- Page changes to the *Completion Report for the UMTRA Project Vitro Processing Site, Salt Lake City, Utah*, dated August 1996. Please replace these pages with the ones that are currently in the March 1995 version of the Vitro Completion Report.
- Response to Comments, Vitro Completion Report
- Vitro Processing Site, Post-Remedial Action Status

VITRO PROCESSING SITE POST-REMEDIATION ACTION STATUS

RESPONSE TO COMMENTS VITRO COMPLETION REPORT

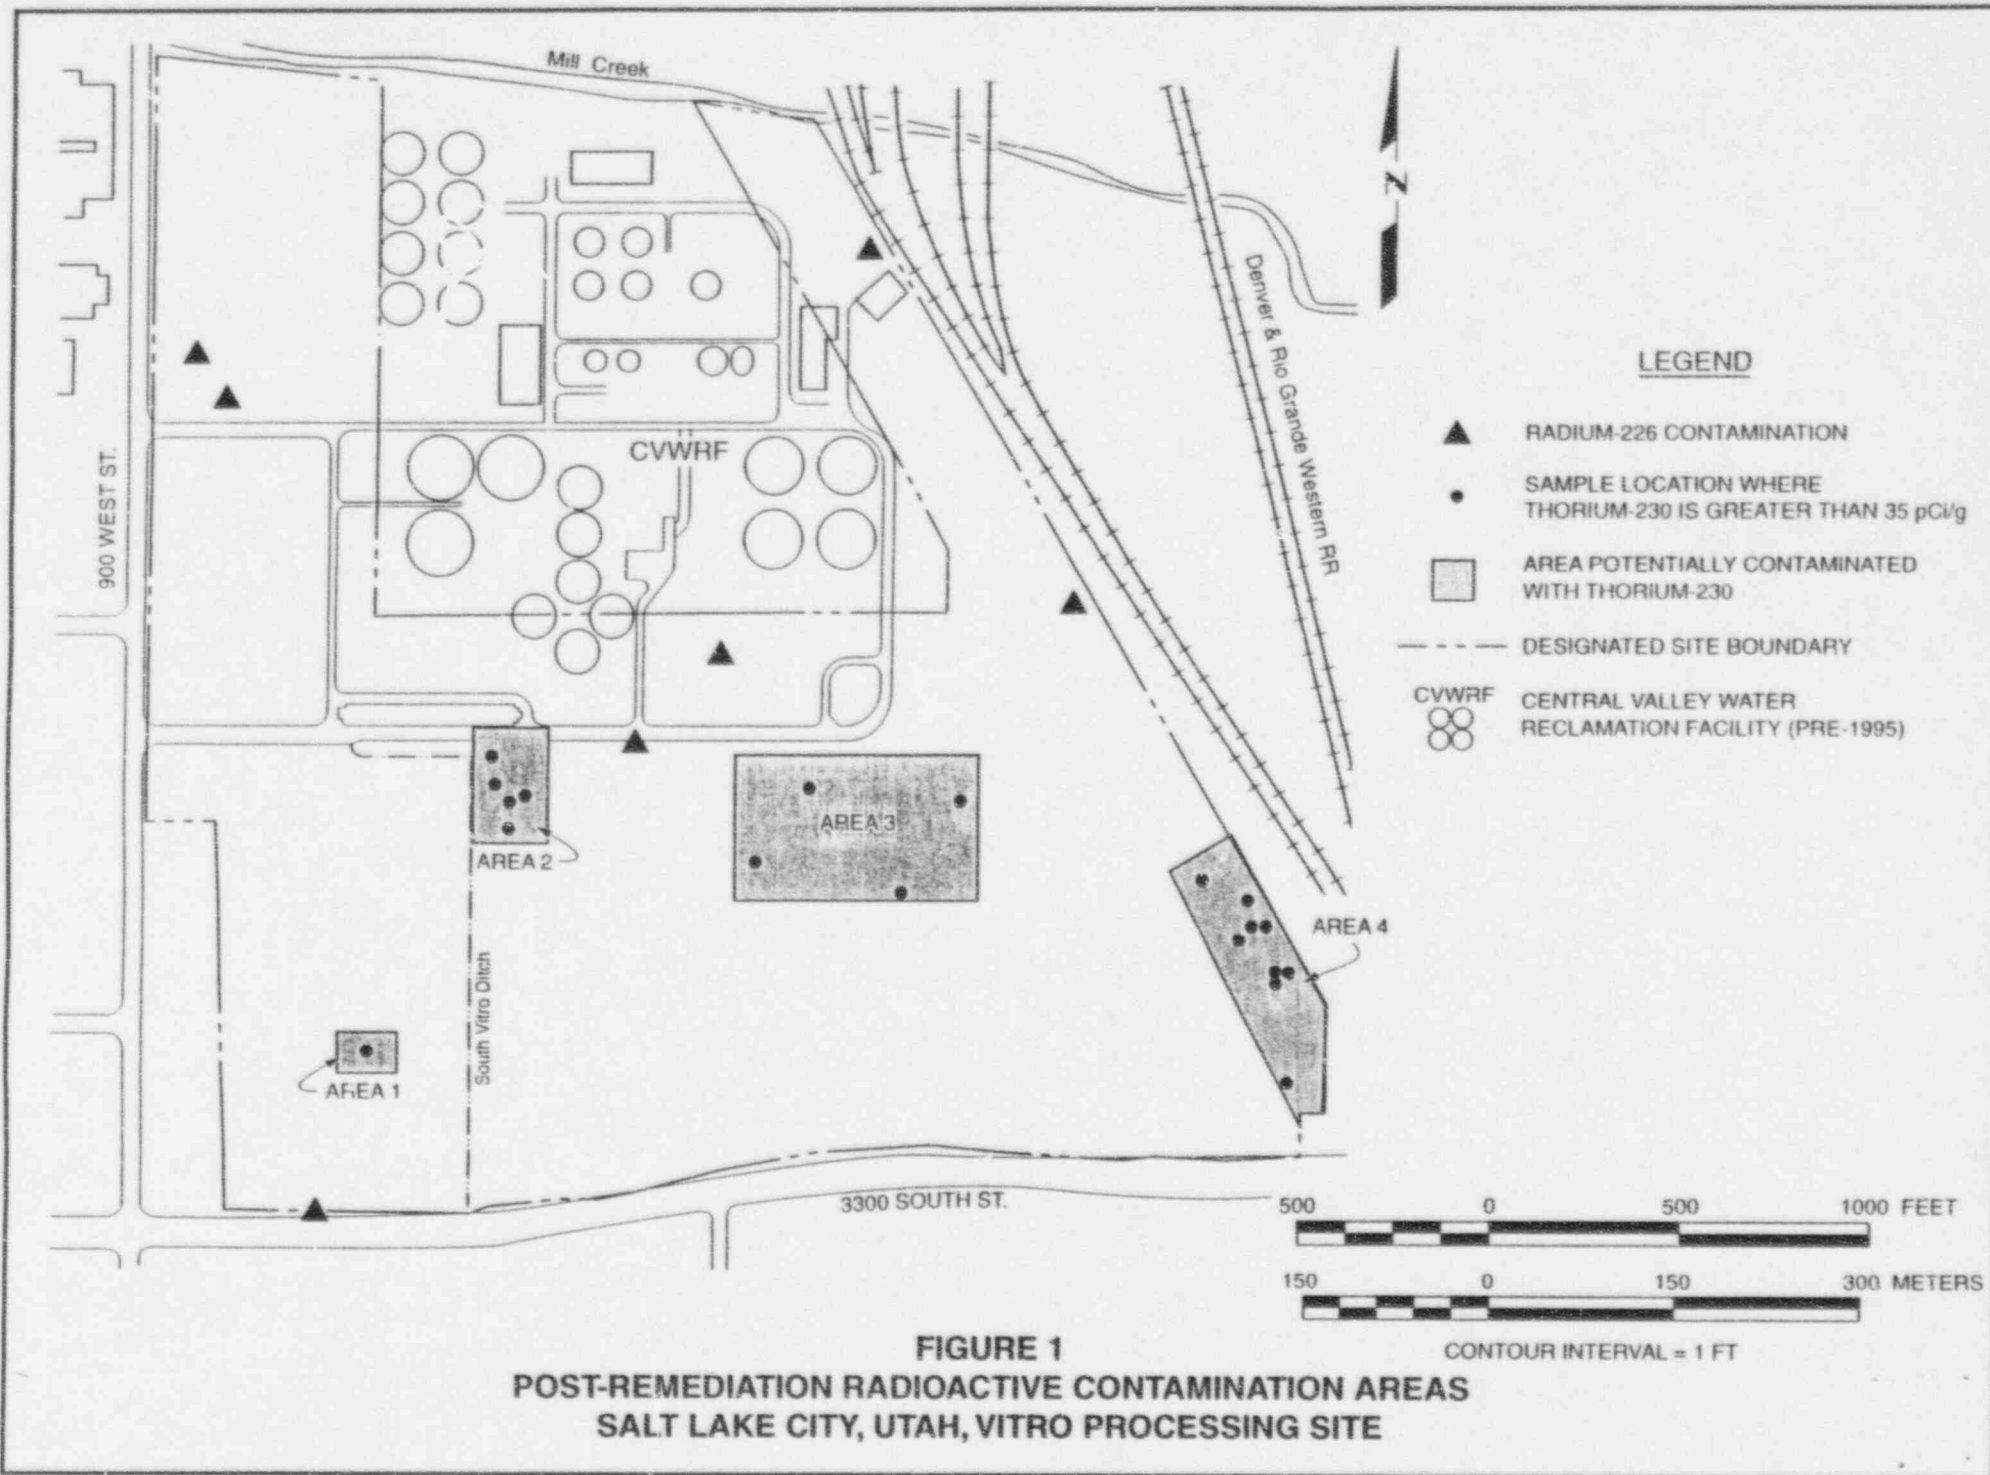
1. Th-230 data in Table 6-1 that is consistent with the data that is presented in Appendix B. Specifically the DOE should discuss the Th-230 contamination as four distinct areas of known Th-230 contamination (DOE only identifies two distinct areas) and revise the Ra-226 values of grids 627-2178 and 759-2145.
2. revise the information in Section 6.4 to describe the elevated Th-230 as four distinct areas (rather than discussing 24 individual grids) and to provide a reason for and possible size of the Th-230 soil sample in the southwest corner of the site that has a Th-230 concentration of all 650 pCi/g.
3. a revised estimation of the volume of material containing elevated Th-230 (NRC estimated 1580 m³ and DOE estimated 1507 m³).

1. Table 6.1 and Figure 6.1 has been revised to show the elevated Th-230 as four distinct areas on the Vitro site. The Ra-226 data has been revised in Table 6-1 for grids 1056N-066E, 1353N-297E, 627N-2178E and 759N-2145E.
2. Section 6.4 has been revised to discuss the elevated Th-230 as seven distinct areas rather than individual grids. In addition, a discussion has been added to outline possible reasons for the existence of each of the areas including an estimated quantity for each area.
3. The quantity of Th-230 has been re-estimated for each of the grids containing elevated Th-230 (see Table 6.1). DOE used a value of 1480 m³. This number was determined by multiplying the 24 grids by the grid area of 101 m² (33 feet x 33 feet grids) and by the estimated thickness of 0.61 m (2 feet).
